# SERVICE BULLETIN

No. 526A

Piper Aircraft Corporation

Pilot/Copilot Microphone and Phone Jack Relay  
Modification

### PILOT/COPILOT MIKE AND PHONE JACK RELAY DETAIL

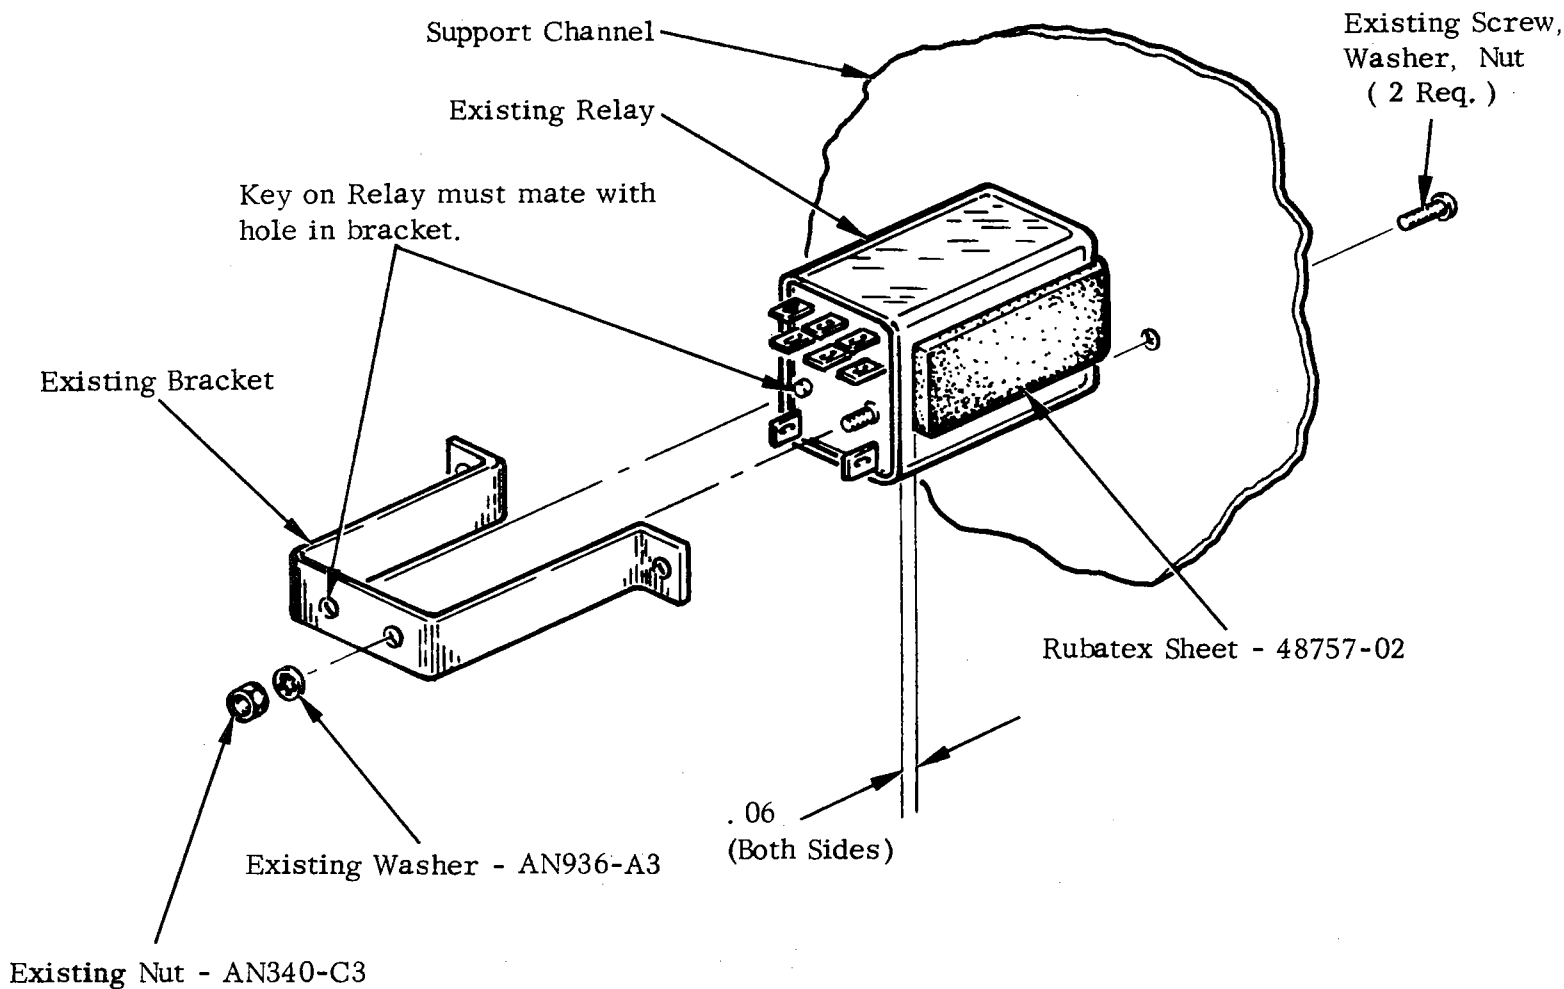
Purpose: Intermittent operation of the copilot's microphone was determined to have occurred as a result of the pilot/copilot's microphone and phone jack relay loosening (through vibration) from its mounting bracket. This can, in turn, cause the 28 volt pin on the relay coil to contact the mounting bracket, causing an electrical short.

This Service Release provides material and instructions for applying a rubber strip to the relay assembly, to dampen vibration and increase the rigidity of the mounting bracket.

1. Ensure master switch is off.
2. Locate pilot/copilot mike and phone jack relay, as shown in detail above. The relay will be located near the copilots mike and phone jack.
3. Remove relay and attaching bracket as one unit. Retain hardware for reinstallation.
4. Disconnect relay from bracket. Retain washer and nut for reinstallation.
5. Wrap rubatex sheet 48757-02 around relay and trim to dimension shown above. Attach existing relay, with rubatex sheet, to existing bracket as shown using existing nut and washer.
6. Reinstall switch and bracket assembly to aircraft using existing hardware.
7. Make proper logbook entry of Service Bulletin 526A Compliance .
